East Anglia TWO Offshore Windfarm

Offshore Ornithology Without Prejudice Compensation Measures

Applicant: East Anglia TWO Limited
Document Reference: ExA.AS-~~4.D12.V4~~6.SoSQ2.V5 Tracked
SPR Reference: EA2-DWF-ENV-REP-IBR-001090 Rev 05

Date: ~~28th June 2021~~31st January 2022
Revision: Version 45
Author: MacArthur Green / Royal HaskoningDHV

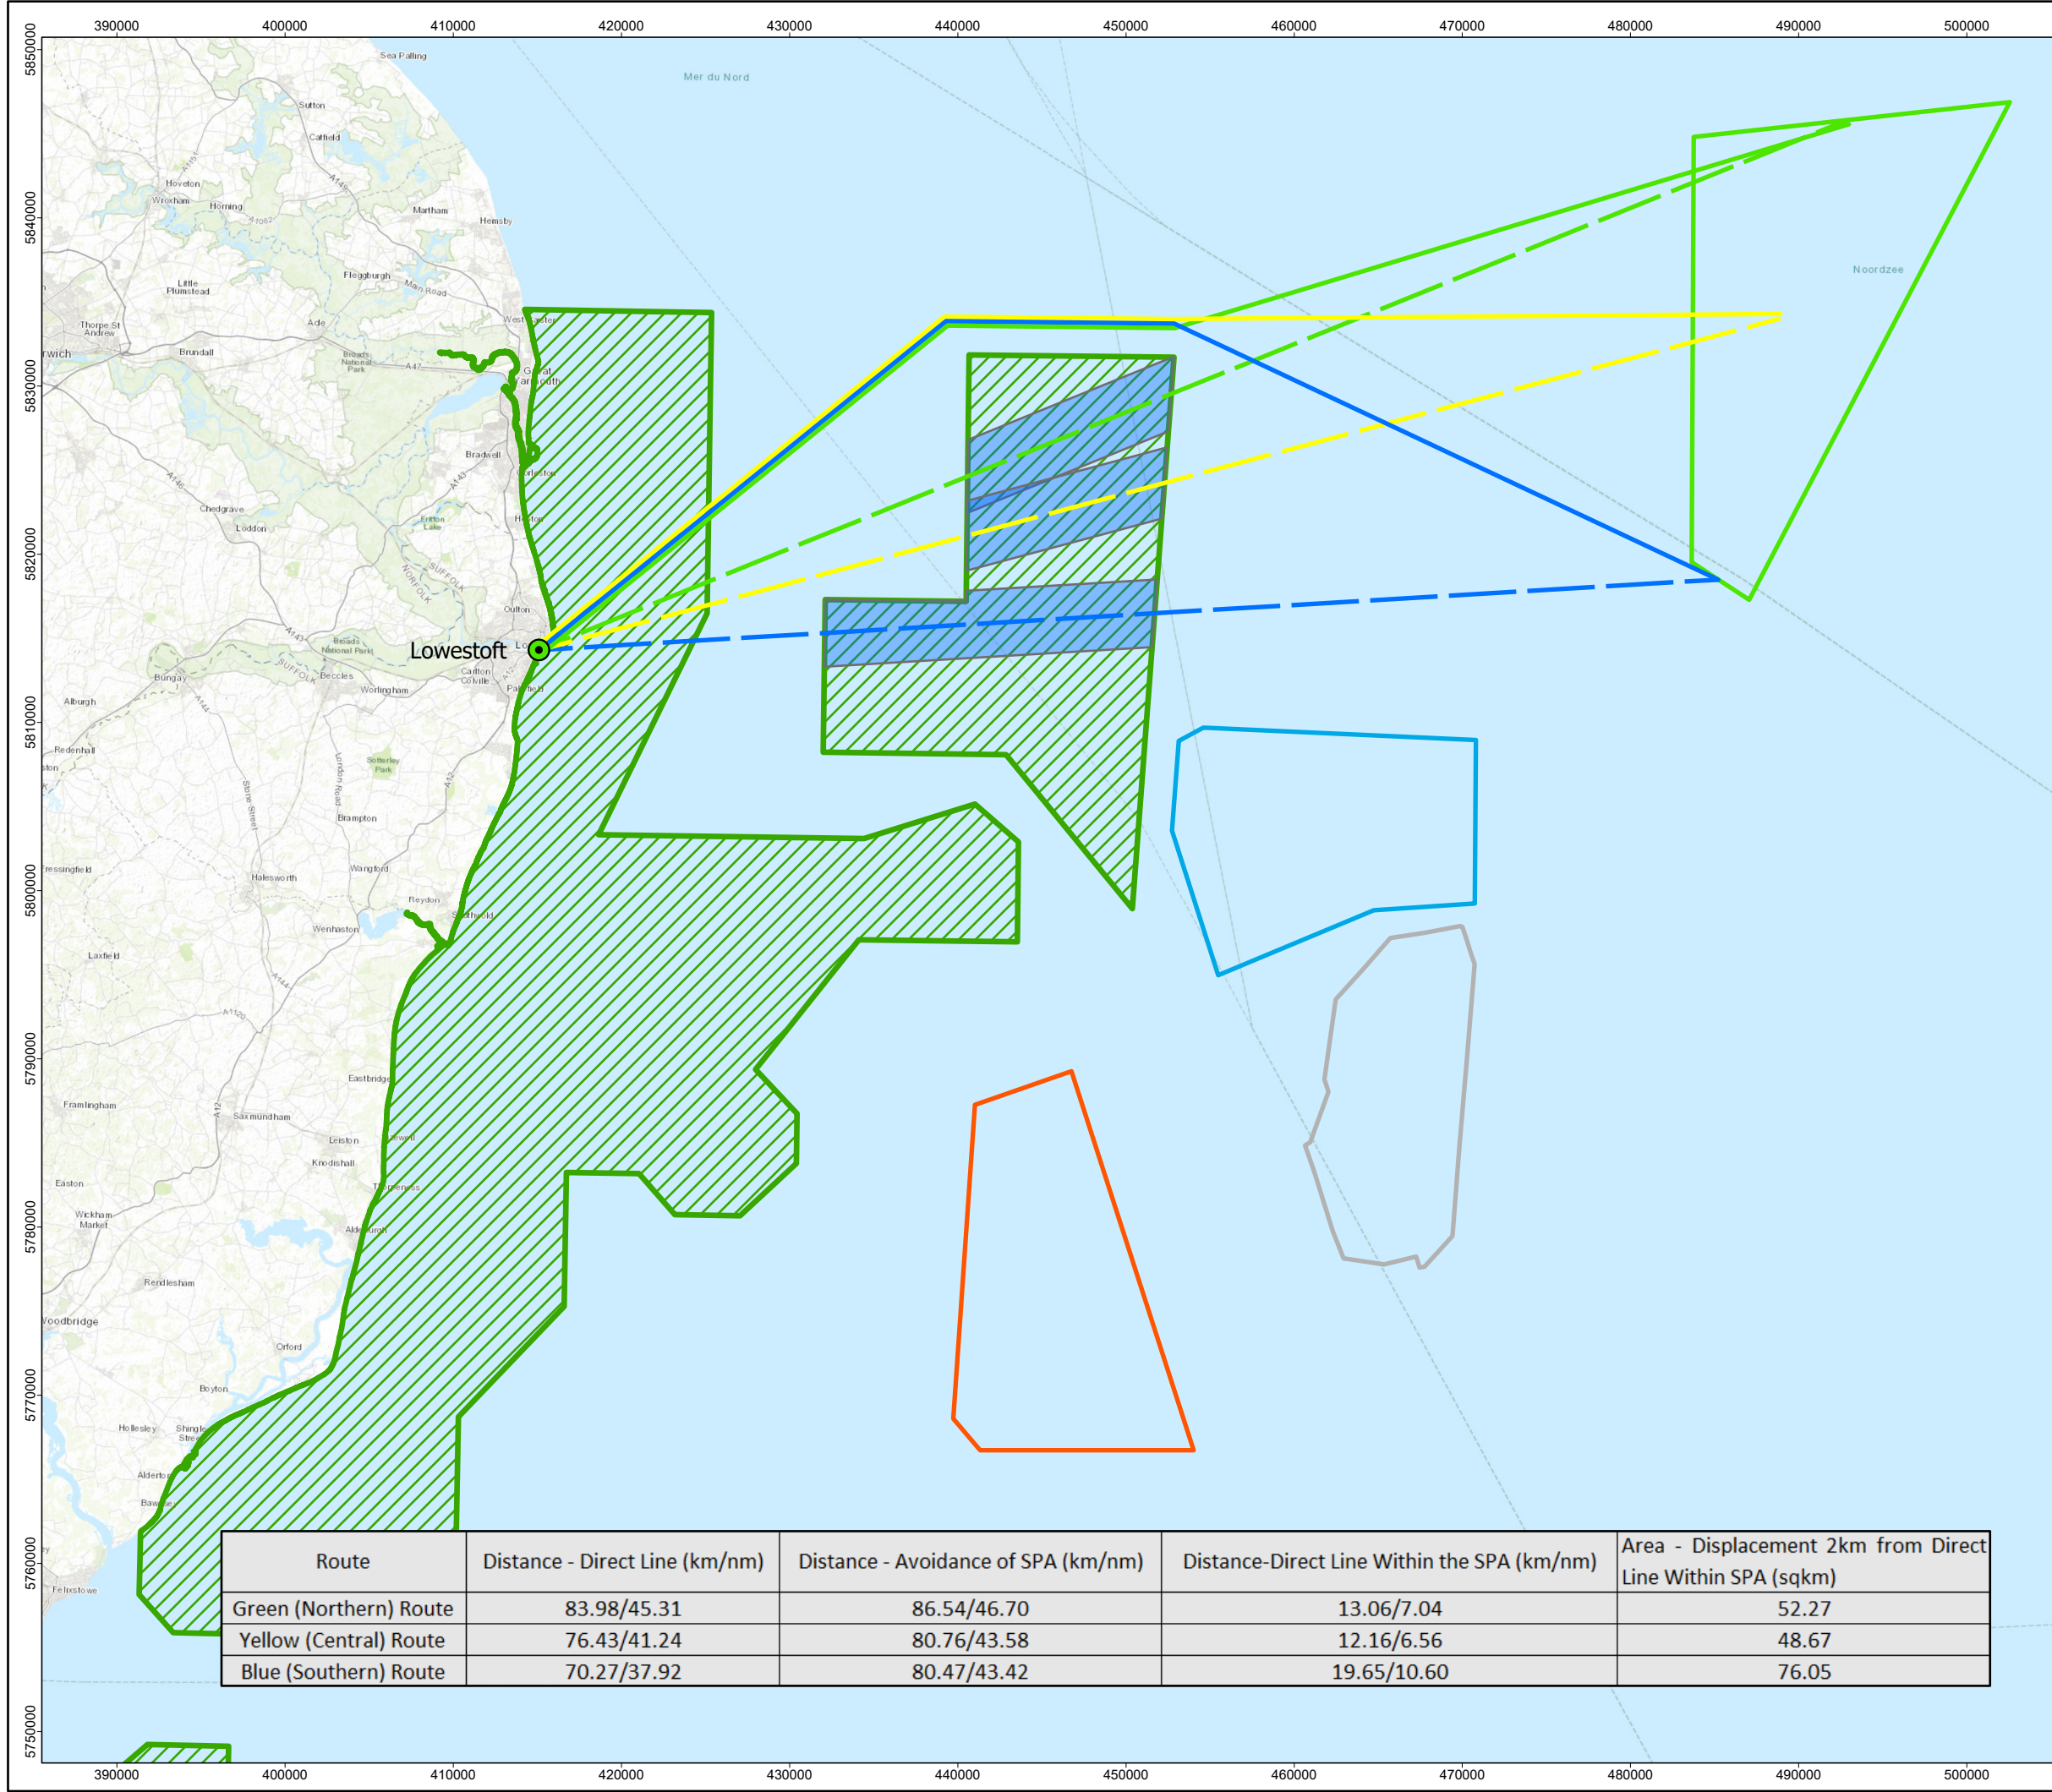
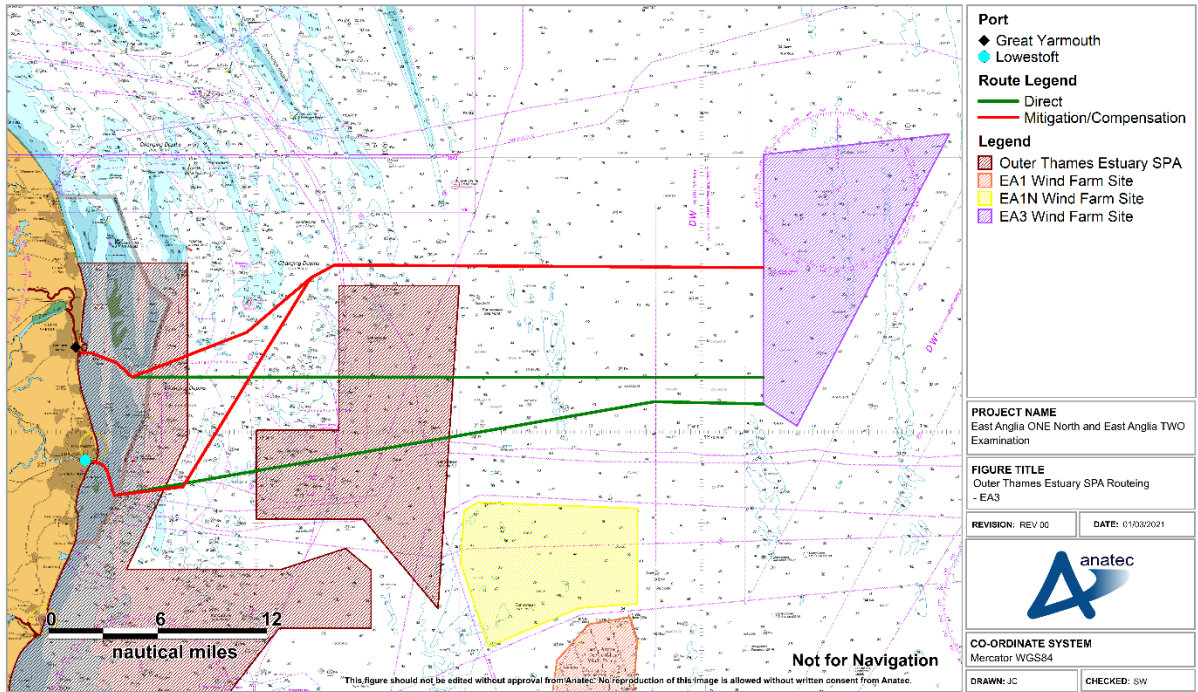
269. The Applicant ~~commissioned Anatec Limited to establish~~ has established vessel transit routes from ~~both ports~~ the port of Lowestoft to the East Anglia THREE and East Anglia ONE windfarm ~~sites~~ sites avoiding, as far as possible, the SPA with a 2km buffer either side of the route ~~to account for the range over which red-throated diver are known to flush from vessels in transit.~~

255-270. The results of ~~that exercise~~ those exercises are shown in **Figure 10.1 (East Anglia THREE)** and **Figure 10.2 (East Anglia ONE)** where the ~~anticipated~~ illustrative 'direct routes' that could have been taken from ~~each port (Great Yarmouth to the north and Lowestoft to the south) to the windfarm site~~ are shown in 'green' sites prior to this re-routing and the 'mitigation/subsequent compensation routes' in 'red' routes are clearly shown.

256-271. The main component of the SPA overlaps the approaches to ~~both ports~~ the port of Lowestoft and therefore it is not possible to avoid transiting through this part of the SPA. However, the re-routes have been specifically created to follow the navigation approaches to ~~both ports~~ the port, and thus limit the impact of the Projects' projects' vessel movements to areas of existing navigation routes associated with ~~the ports, where the densities of red-throated diver are typically relatively low~~ Lowestoft.

258-273. Once beyond the main component of the SPA, vessel traffic from Lowestoft to and from East Anglia THREE has been re-routed to avoid the northern component of the SPA beyond the approaches to the ports would be maintained. (as shown on Figure 10.1).

Figure 10.2 Vessel routing measures for East Anglia ONE ~~North and East Anglia TWO~~

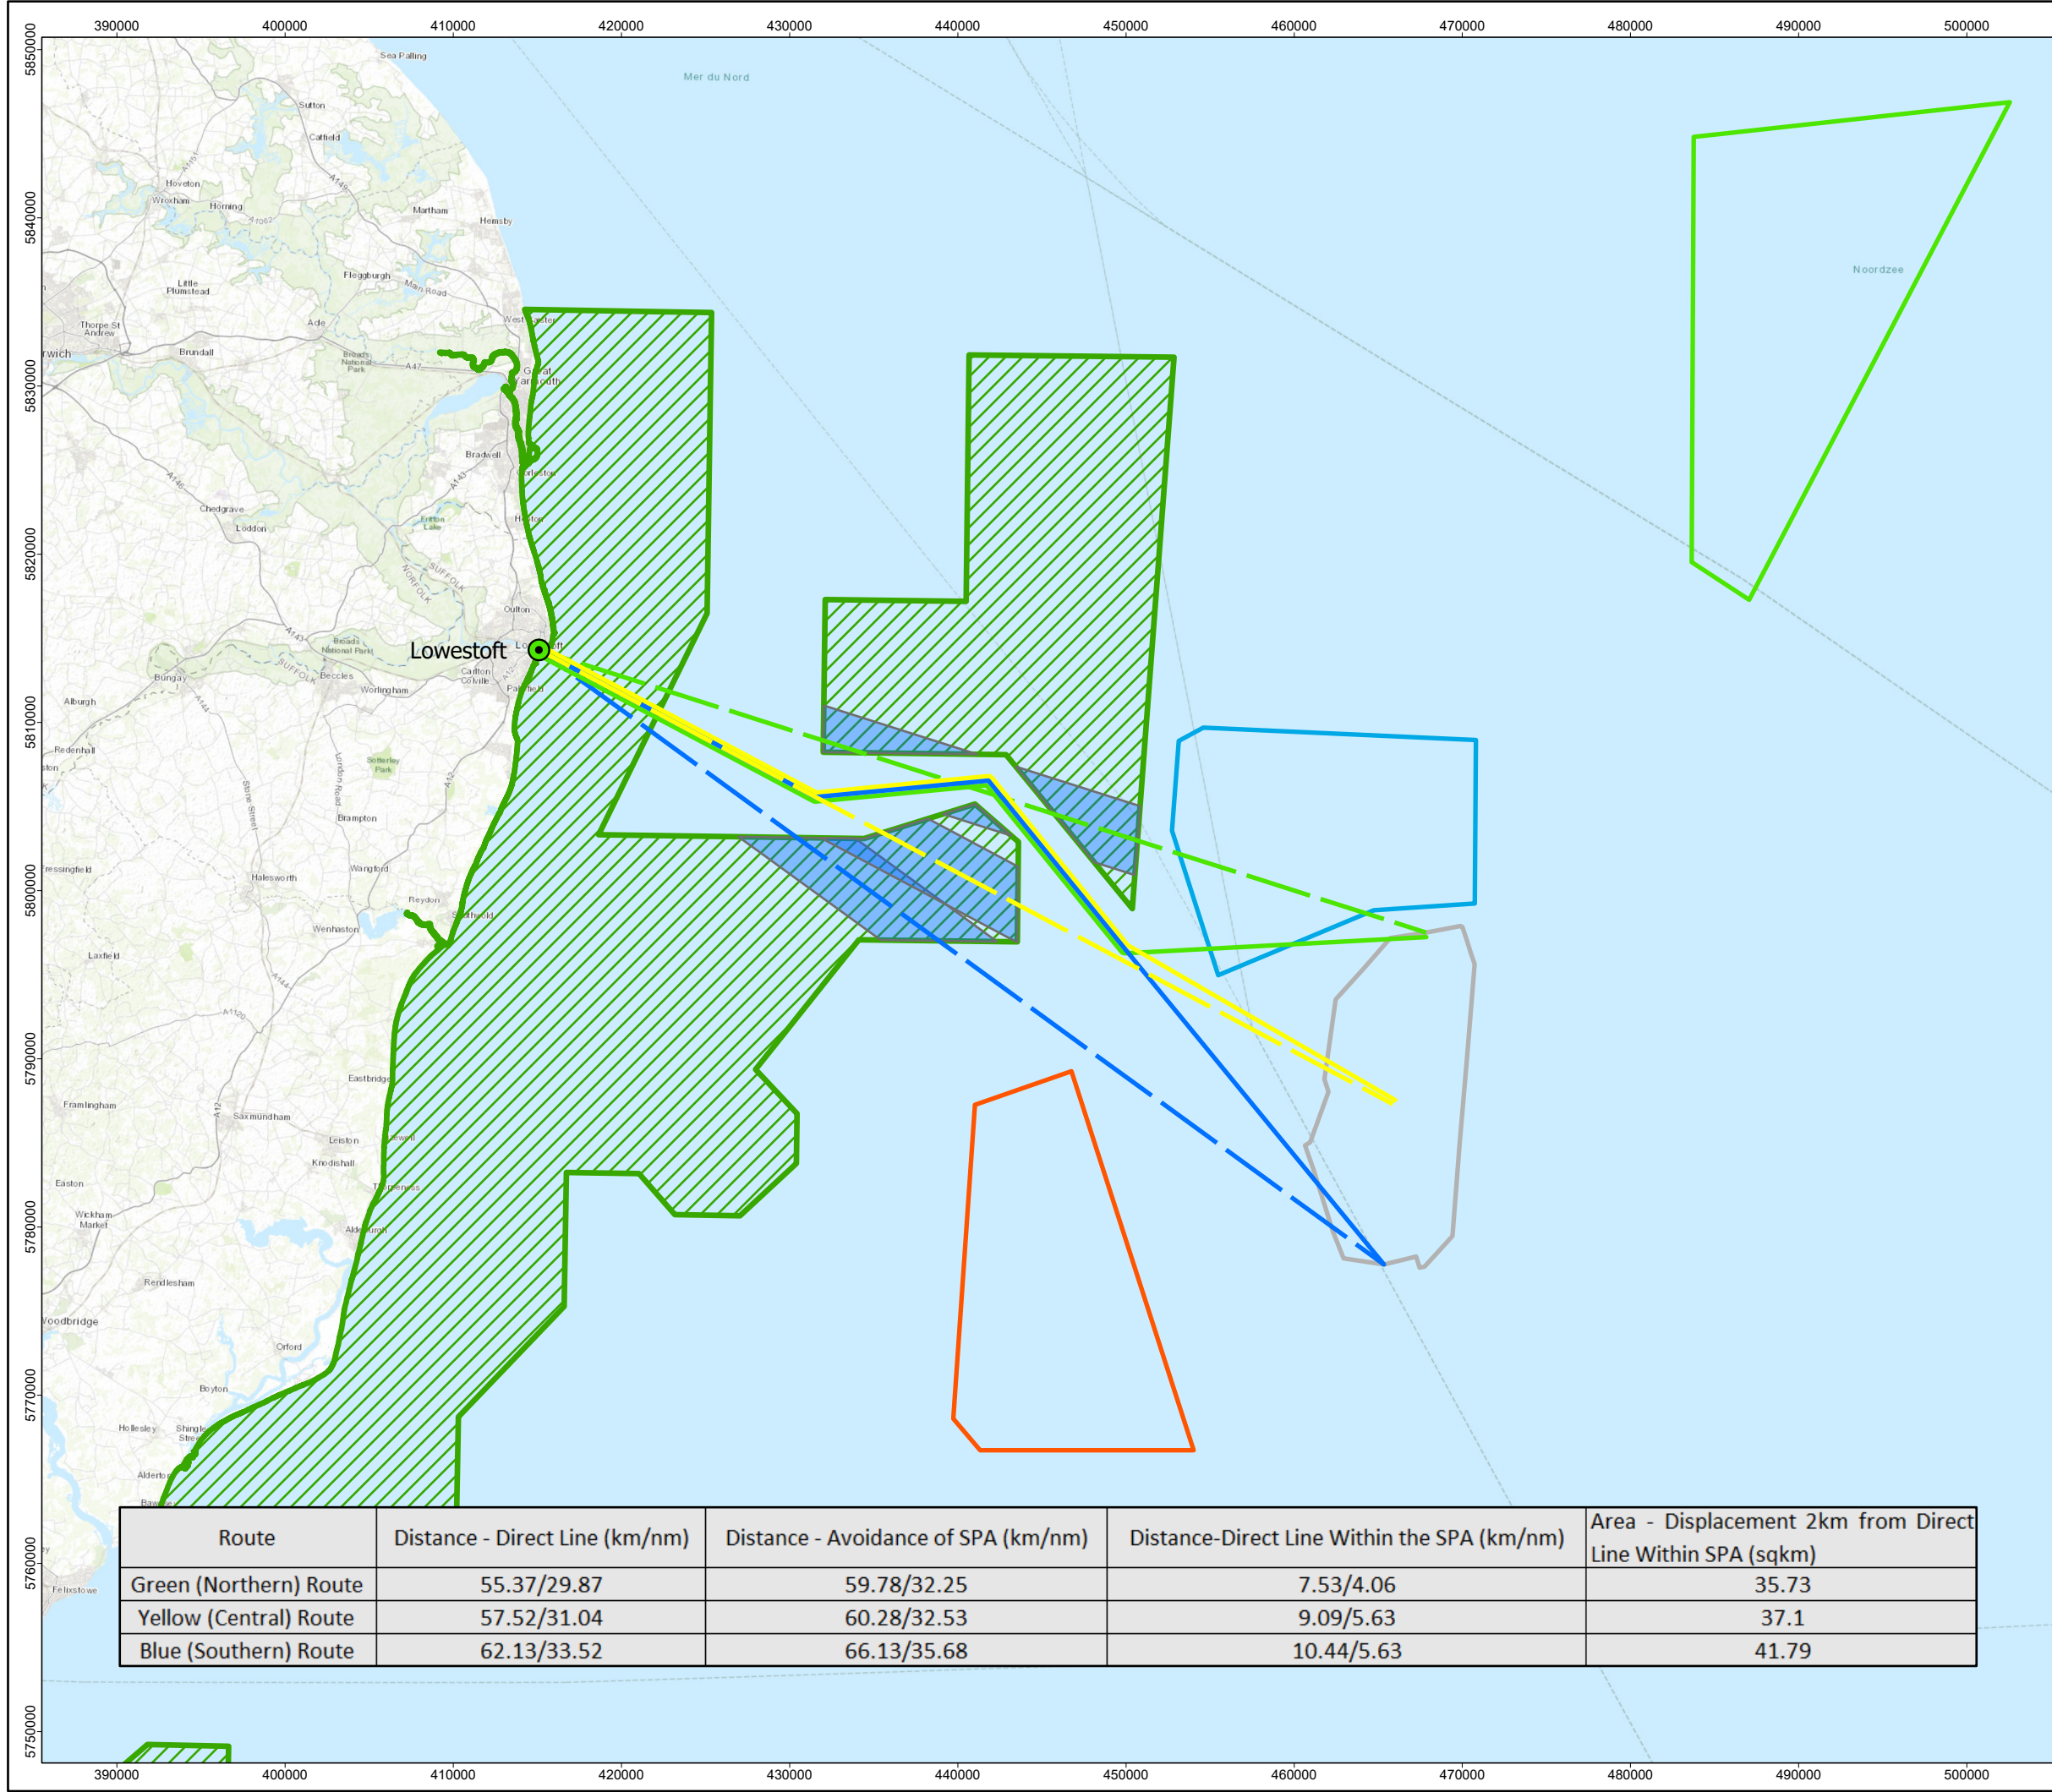
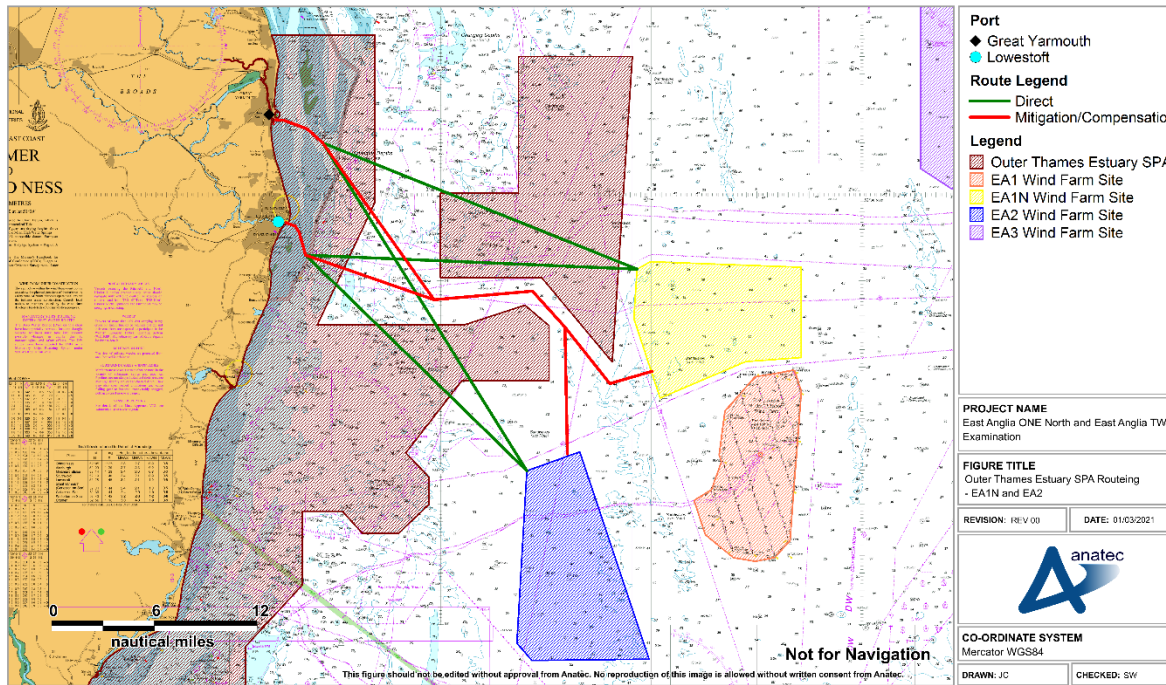
277. The EA1N Offshore Ornithology Without Prejudice Compensation Measures document (REP12-060) explained that re-routing of operation and maintenance vessels between Lowestoft and East Anglia THREE would reduce a frequent temporary impact of approximately 80km². The basis of this calculation was explained in REP12-060 under **paragraph 260** and **Figure 10.1**
